Access Compliance Report Public Rights-of-Way (Curb Ramps)

Intersection ID: N/A	Main Street: E_STONEWALL_ST	Cross Street: S_DAVIDSON_ST	Location: SE
ADA ID: 9626B8FA9B49	Ramp Type: Perp	Initial Pass/Fail: Fail	Overall Compliance: No Severity Score: 12.5

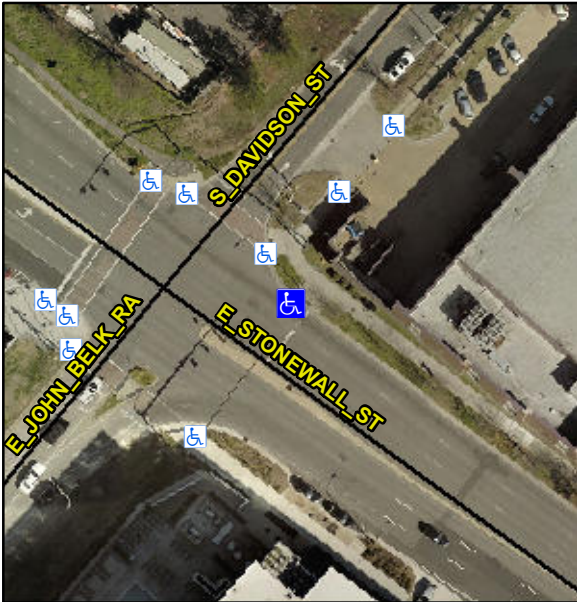
Not Found, R304.2.2

Compliance	Description	Data	Compliance	Description	Data
N/A	Ramp Length (in)	110.0	No	Ramp Slope (%)	8.6
Yes	Ramp Width (in)	48.0	Yes	Ramp XSlope (%)	1.5
N/A	Flare Type LT	N/A	N/A	Flare Type RT	N/A
N/A	Flare Slope LT (%)	N/A	N/A	Flare Slope RT (%)	N/A
N/A	Flare Traversable LT?	N/A	N/A	Flare Traversable RT?	N/A
N/A	Landing Length (in)	N/A	N/A	DWS Provided?	N/A
N/A	Landing Width (in)	N/A	N/A	DWS Contrast?	N/A
N/A	Landing Slope (%)	N/A	N/A	DWS Length (in)	N/A
N/A	Landing X Slope (%)	N/A	N/A	DWS Full Width?	N/A
N/A	Landing Curb? (Y/N)	N/A	N/A	DWS Offset (in)	N/A
N/A	Shared Landing?	N/A			
N/A	Gutter Ponding?	N/A	N/A	Gutter Slope (%)	N/A
N/A	Gutter Lip Ht (in)	N/A	N/A	Gutter X Slope (%)	N/A
N/A	Painted X Walk1?	No	N/A	Painted X Walk2?	N/A
	X Walk 1 Direction	To SW		X Walk 2 Direction	N/A
N/A	X Walk 1 Width (in)	N/A	N/A	X Walk 2 Width (in)	N/A
	X Walk 1 Slope (%)	1.3		X Walk 2 Slope (%)	N/A
	X Walk 1 X Slope (%)	2.1		X Walk 2 X Slope (%)	N/A

Remove & Replace Entire Ramp.
